Grady Ranch Precise Development Plan

Final Supplement to the Grady Ranch/ Big Rock Ranch Master Plan 1996 Final Environmental Impact Report

January 2012

Revised Exhibit 2-11

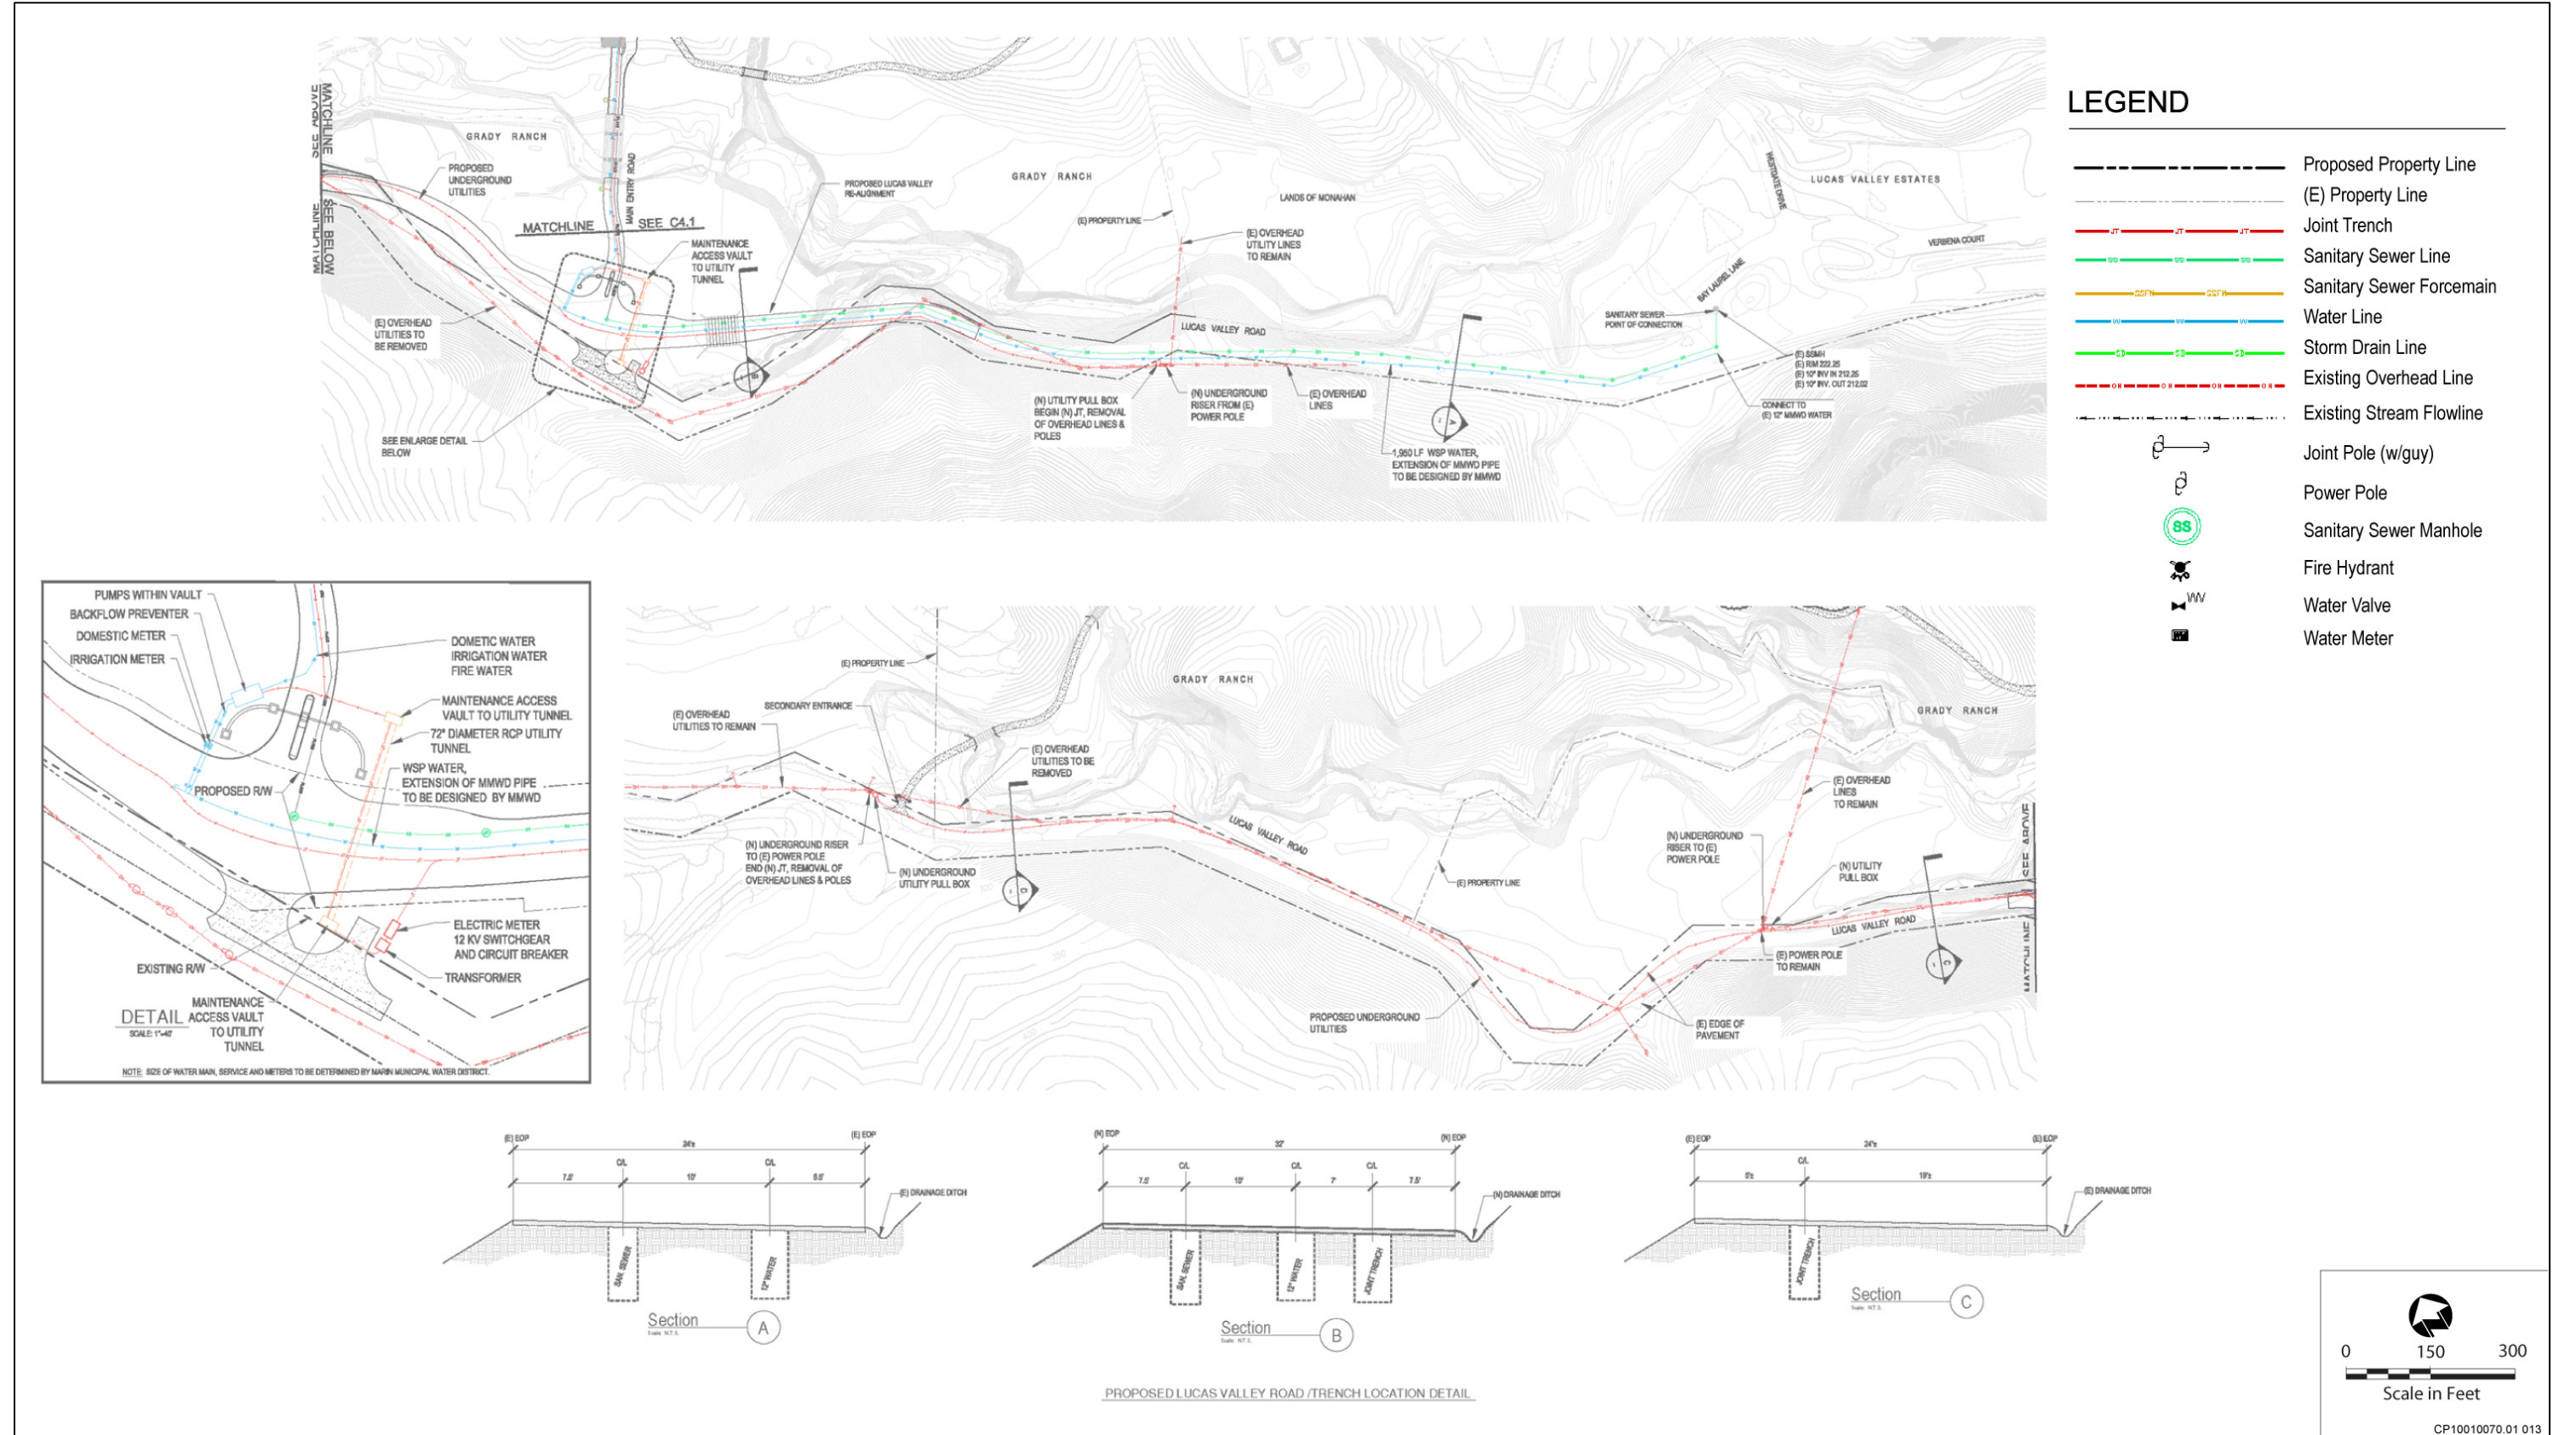
Page 2-29, Exhibit 2-11, Onsite Utility Improvements – The governing fire district will determine the fire flow requirements for the proposed project, not MMWD as stated in Exhibit 2-11 concerning the size of the proposed 400,000-gallon water storage tank. The reference to a determination that the size of or the need for a proposed 400,000-gallon water storage tank intended to provide fire suppression would be MMWD's is incorrect. Finally, MMWD does not "stack" water services over each other, due to the maintenance and service issues it presents. All water services to the project site will be located within their own separate trench with no other utility services above or below.

- 6-4 The comment that all landscape plans must be reviewed and approved by MMWD prior to granting water service to the property is noted.
- 6-5 Exhibit 2-11 has been revised to remove the statement that MMWD is responsible for verifying that municipal supply will meet fire flow demand.

Exhibit 2-13

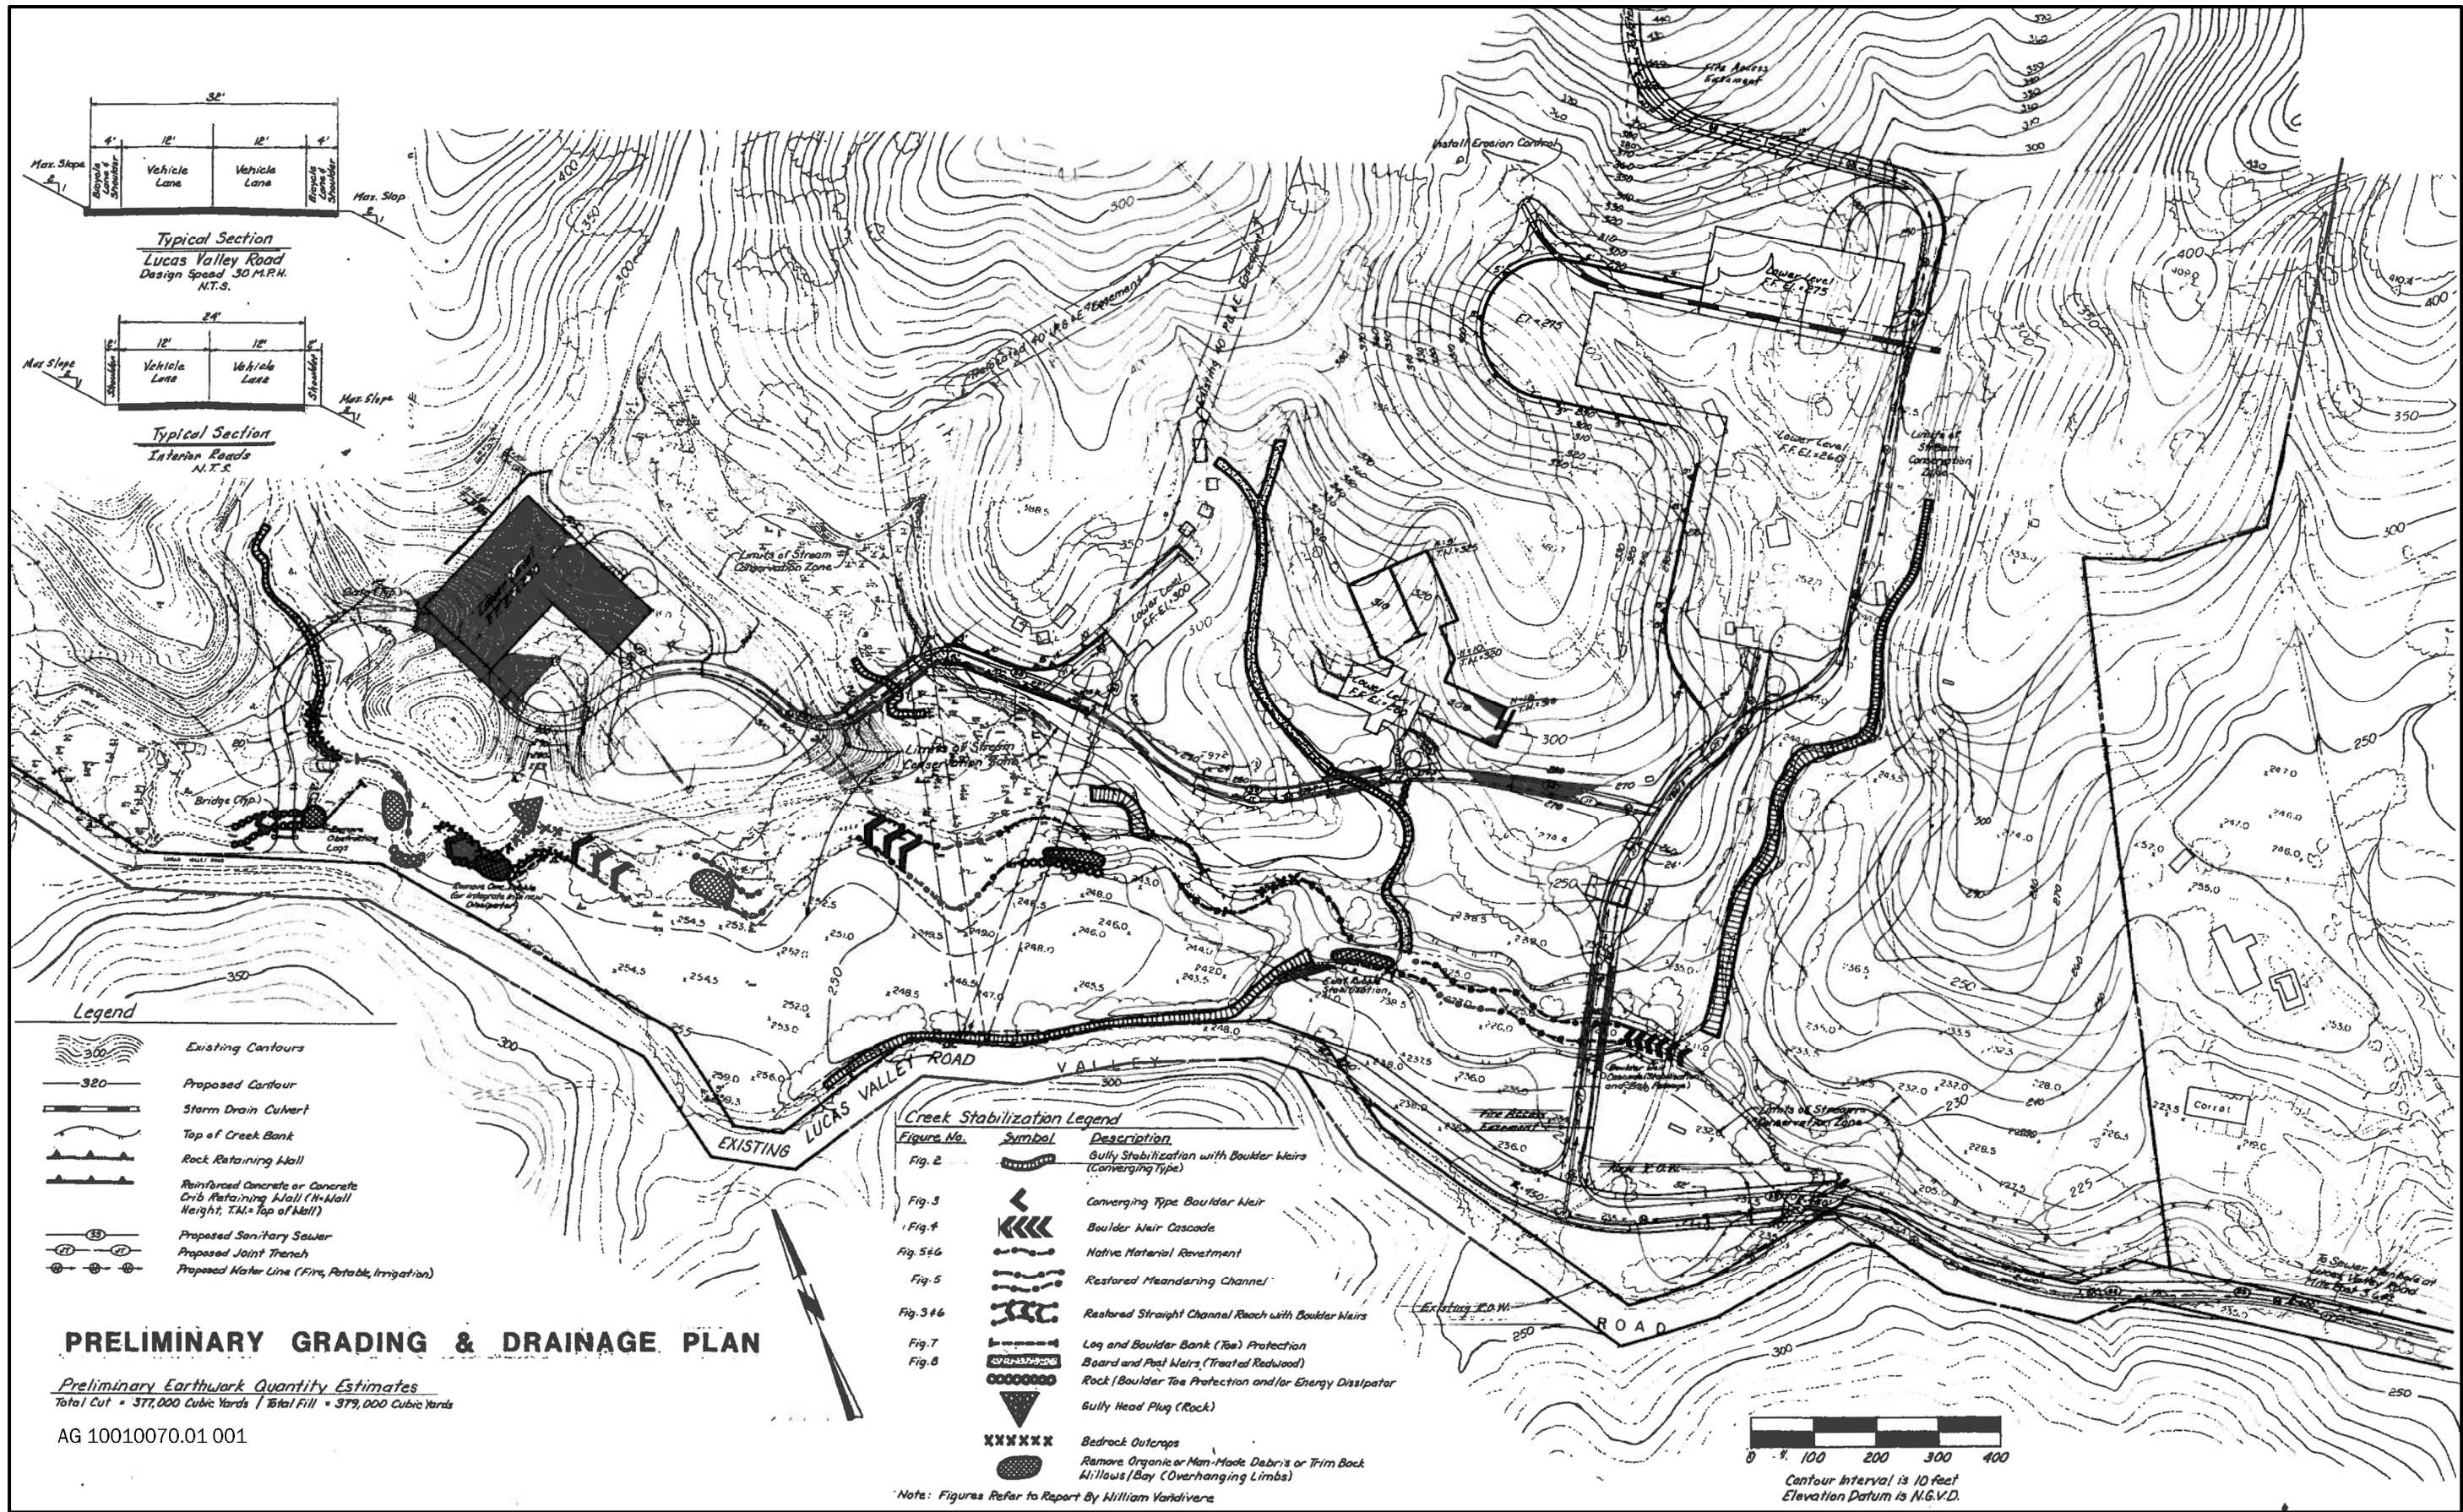
| Table 2-2: Changes from the Previous Master Plan to the Proposed Grady Ranch Precise Development Plan | | |
|---|--|--|
| SCA | Install boulder cascades immediately downstream of the existing Grady Bridge and removal of debris upstream of the new Grady Bridge. See Exhibit 2-13, which includes the 1996 Master Plan preliminary grading plan, for a comparison of the previous grading plan with the proposed site plan (Exhibit 2-2) and the proposed grading plan (Exhibit 2-7). | SCA Restoration and Enhancement Plan would raise the bed of Miller Creek upstream of the new Grady Bridge and would include boulder weirs |

Valley Road. Exhibit 2-13 was part of the 1996 Master Plan and Use Permit (MP/UP) and Exhibit 2-8 is part of the Grady Ranch PDP. Exhibit 2-13 shows the overall extent of restoration work proposed at the MP/UP phase and, as noted, the exhibit is provided for comparison purposes. The extent of work for the proposed PDP would be similar. However, the text on pages 3-29 and 3-30 of the Draft SEIR is revised to read as follows to include some additional discussion of potential impacts to riparian and aquatic habitat as a result of stream restoration:
